# UNITED STATES PATENT AND TRADEMARK OFFICE

**Office Action Summary**

10/765,117

## **DETAILED ACTION**

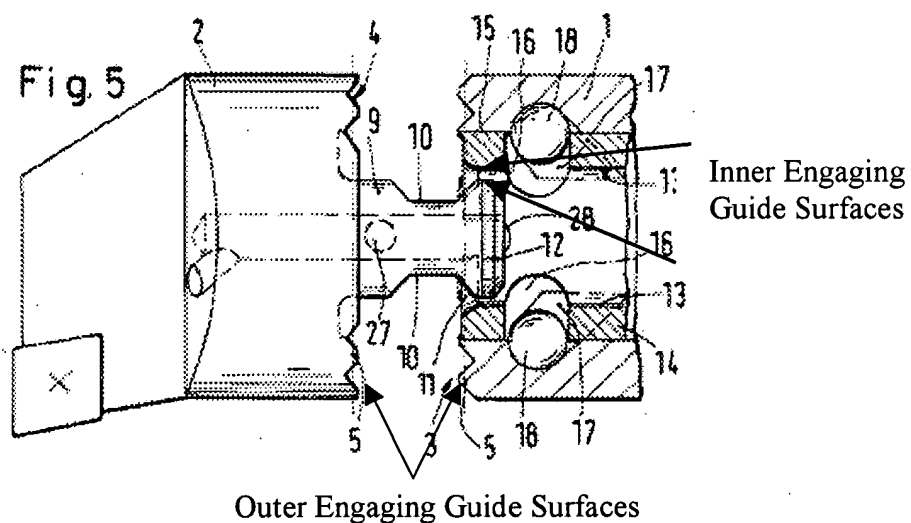
5. Claims 1-8, 11 and 14 are rejected under 35 U.S.C. 102(b) as being anticipated by US Pat. No. 4,655,655 (Schürfeld, hereafter ‘655).

‘655 teaches a tool and workpiece holding arrangement with the first and second tool holders (see area of reference numbers 1 and 2 of figure 1) being clamped together in an axial direction by a force applying member (see figures 5 and 6, and reference numbers 18, 14, for example); the first body including an axially extending male part 9,10, the second body including an axially extending female part (see figure 5, area between walls 13) in which the male part is

received (see figure 5); first and second guide structures (see figure 5 below) for guiding the structures in the radial direction, the first guide structure with radially outer engaging guide surfaces with ridges and grooves and the second guide structure with radially inner guide surfaces (see figure 5 below); the inner guide surfaces with a cylindrical projection and cylindrical recess of complementing shape (see figure 5 below).

Regarding claim 5, though '655 does not expressly disclose the groove 5 has a radius of curvature larger than the radius of curvature of the ridge 5, it is inherent that the groove 5 has a radius of curvature larger in order for the ridge to fit within the groove (see figure 6, for example).

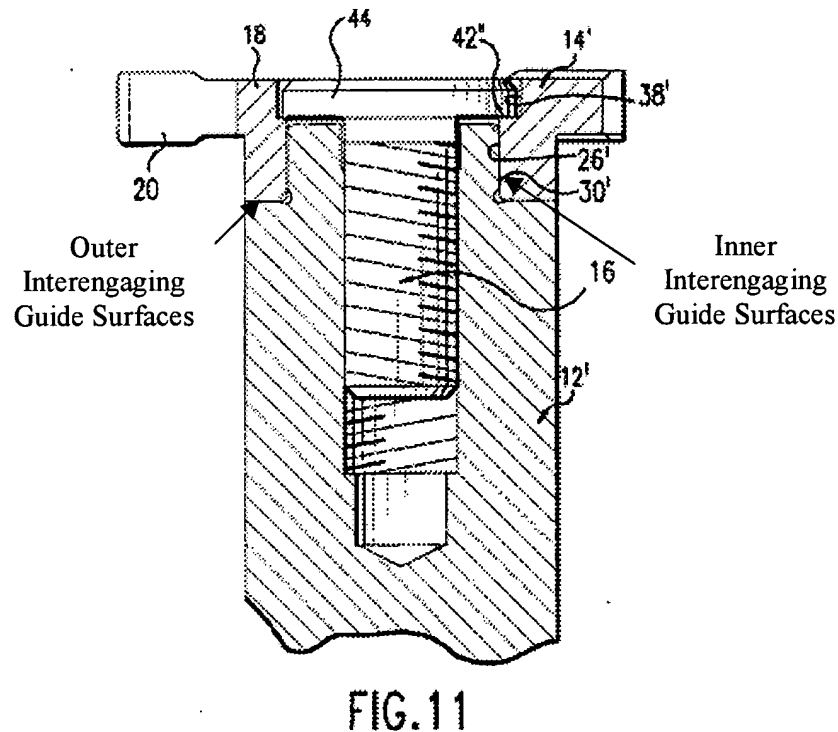
6. Claims 1 and 8-14 are rejected under 35 U.S.C. 102(b) as being anticipated by US Pat. No. 5,607,263 (Nespeta et al., hereafter '263).

'263 teaches first and second bodies 14, 12 (see figure 4, for example), the first tool body 14 with a male member (area 22 of figure 4) and the second tool body 12 with a female member (area 50 of figure 4); outer and inner interengaging guide surfaces (see fig. 11 below); the male and female parts having a generally triangular cross section (see figures 1 and 3, for example); a force applying screw 16 (see figure 4, for example).

Regarding claim 13, figure 4 shows a chamfer above the threaded portion of the screw 16.
